Project: Adamstown

Subject: Aderrig Phase 2 - RFI response

Quintain Developments Ireland submitted a planning application (Ref: SDZ21A/0014) for Aderrig Phase 2 to the South Dublin County Council (SDCC). The SDCC decision order number 1031 has requested further information in relation to the above application. Specifically, item 1 of the RFI relates to roads and transport issues.

Figure 3– Extract showing perpendicular car parking on “Avenues” in Tandy’s Lane Village

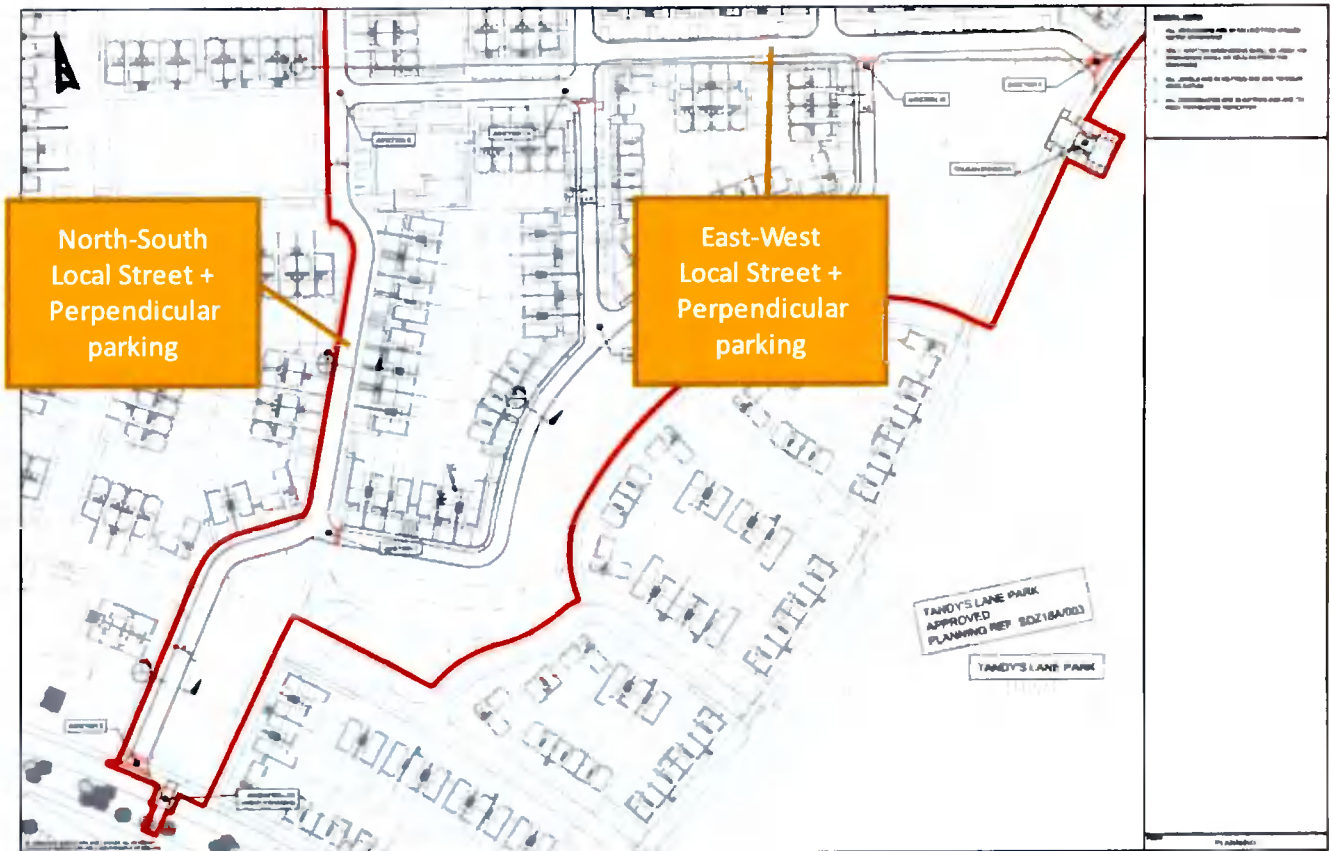
(1) The proposed 64 perpendicular in-curtilage car parking spaces located off Linear Park Road do not appear to be compliant with the Planning Scheme and the Roads Section have raised concerns in relation to traffic hazard. 'Linear Park Road' is identified in the planning scheme as an 'Avenue', the Adamstown Street Design Guide and the Planning Scheme defines as Avenue as: '...Link Streets that provide the main means of access and circulation for public transport services, pedestrians, cyclists and motor vehicles within the SDZ area. The character of these streets will be defined by higher levels of activity, particularly around local centres, nodes and places of civic importance.' Section 6.2 of the Design Guide gives clear guidance on how an Avenue should be designed and constructed. The applicant is requested to demonstrate how the proposed parking complies with the Planning Scheme and the Adamstown Street Design Guide and submit revised proposals to incorporate parallel parking provision along the eastern boundary of the subject site. The Planning Authority understands that this will significantly reduce the parking provision at this location but considers that as the proposed parking provision is at the maximum that is required there is scope to reduce car parking across the Phase 2 lands. Furthermore, there is scope to incorporate more parallel car-parking along the southern boundary at Adamstown Way, similar to the two spaces already proposed in the Parking Strategy.

Figure 2 and 3 are extracts from the above planning drawings that show the typical conditions along the above streets.

The traffic model also shows that the north South Avenue on Tandy's Lane which was downgraded with perpendicular car parking was anticipated to have a higher traffic flow in both the AM and PM periods than Linear Park Road.
